SERVICETEKNOTES

Published by Tektronix Service
Administrative Support

TABLE OF CONTENTS

BACK SIDE OF FLOATING POWER SUPPLY
ASS'Y, 670-2554-05

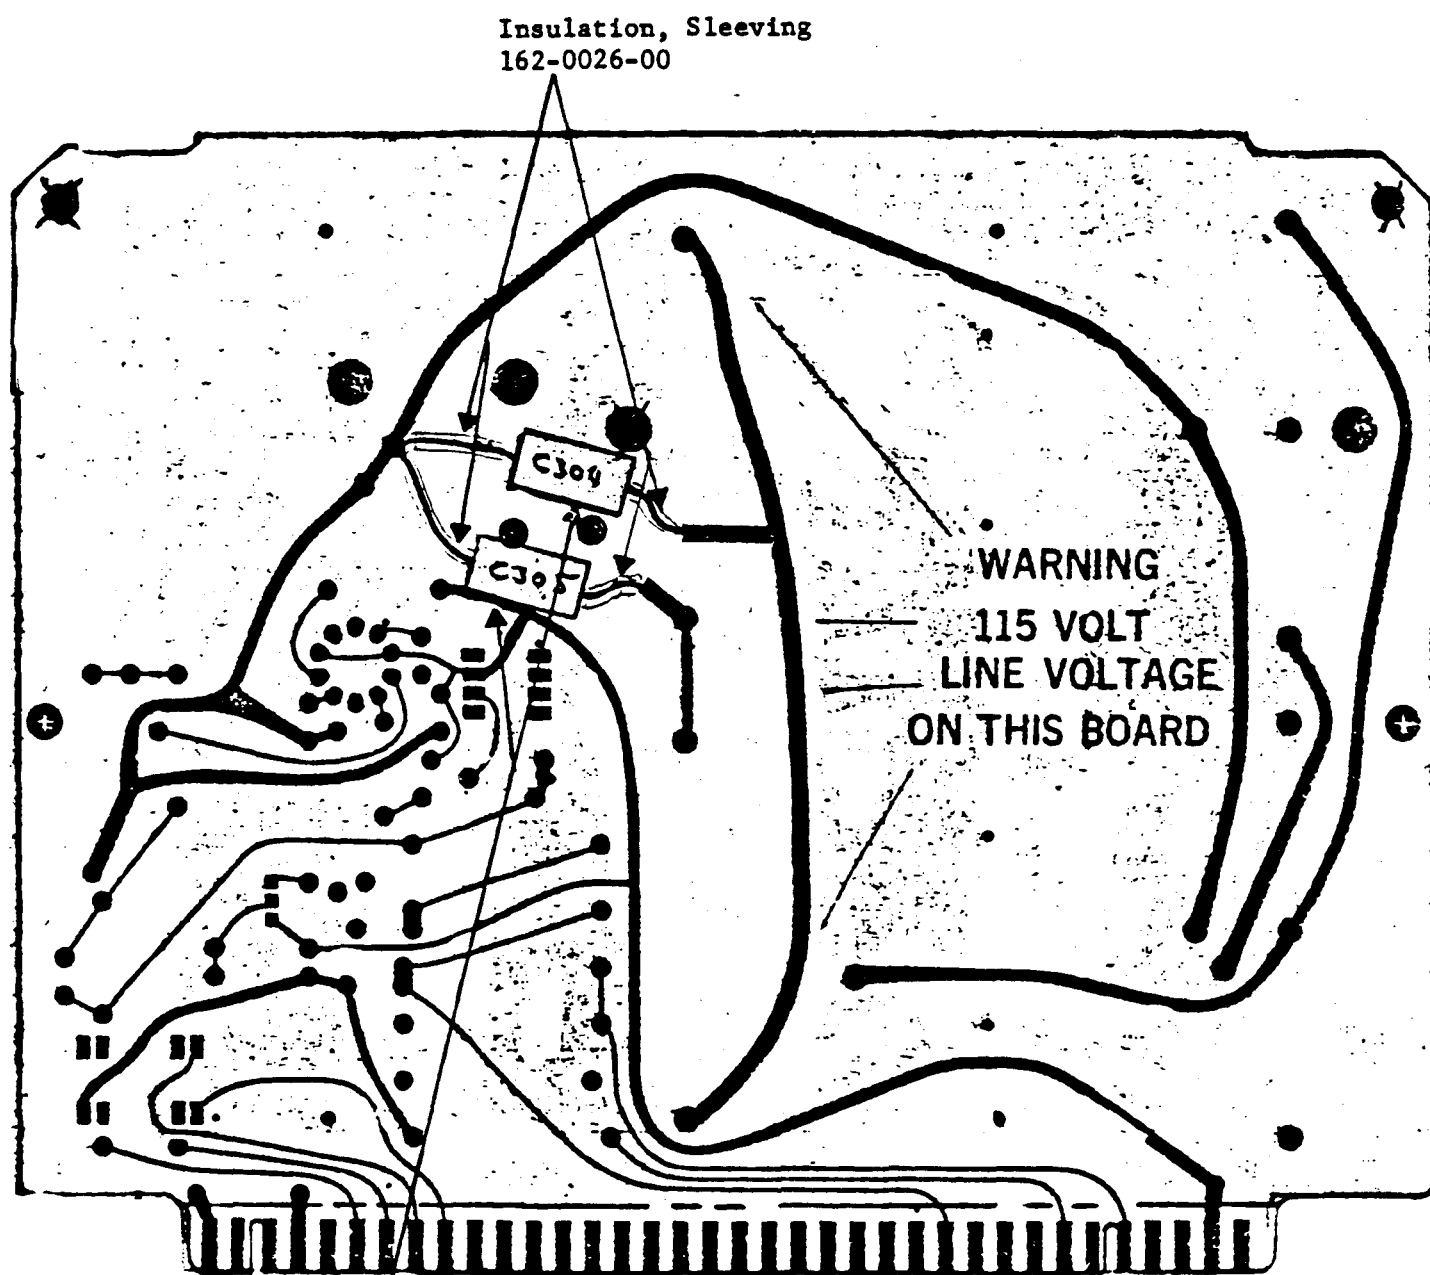
Addition of C304 and C305
(283-0041-00) will bypass noise to
ground. C304 and C305 should be
installed on the back side of the
Floating Power Supply Circuit
Board, 670-2554-04. Installation
of this change also includes
changing the circuit board part
number to 670-2554-05.

MOD M43430 adds two
.0033uf capacitors
(C304 and C305) as
shown above.

C304 & C305
283-0041-00
.0033uF, 5%, 500V

AFTER MOD 43430

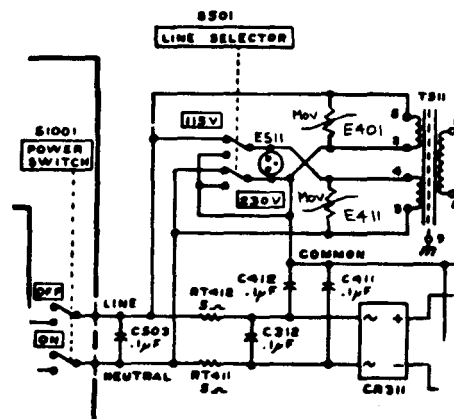
The above added part, E511, is located on the A60A1 INVERTER BOARD and shown on diagram 11a - Partial

A60	620-0286-02	CKT BOARD ASSY:POWER SUPPLY (OPTION 02 & OPTION 05 ONLY)
A60A1	670-6046-02	CKT BOARD ASSY:INVERTER (USED WITH 620-0286-02 ONLY)
A60A1E401	307-0449-00	RES.,VAR,SENSITIVE:1900PF,100A,340V
A60A1E411	307-0449-00	RES.,VAR,SENSITIVE:1900PF,100A,340V
A60A1E511*	119-0181-00	ARSR,ELEC SURGE:230, GAS FILLED
A60A4	670-7444-01	CKT BOARD ASSY:LINE FILTER (USED WITH 620-0286-02 ONLY)
A60A4F1	159-0211-00	FUSE,CARTRIDGE:3AG,5A,250V SLOW BLOW (FOR 115V OPERATION)
A60A4F1	159-0217-00	FUSE,CARTRIDGE:3AG,2.5A,250V SLOW BLOW (FOR 230V OPERATION)

Schematic Changes

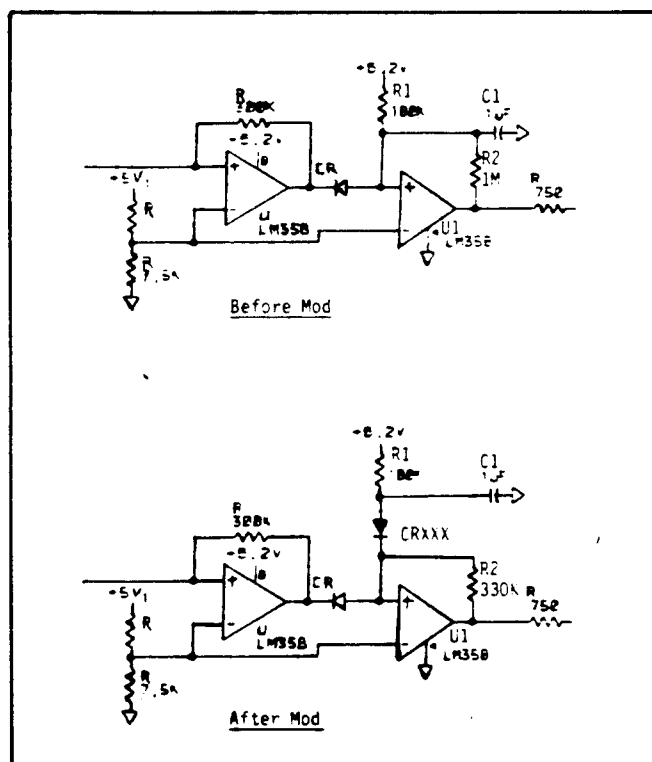
One end of both a 1 uf cap (C1) and a 180K Ω resistor (R1) are connected to the plus input of the OP AMP (U1) in the circuit involved. Lift this end of both components and "teepee" together. Insert and solder in the cathode end of a 1N4152 diode (CRXXX) into the hole from which the end of the "teepeed" resistor (R1) was removed. Connect the other end of the diode to the "teepeed" resistor and capacitor (R1, C1) and solder together. Last, replace the 1M Ω resistor (R2) with a 330K Ω resistor. Below are part numbers for CRXXX and R2.

Diode CRXXX	152-0141-02	1N4152
Resistor R2	315-0334-00	330K
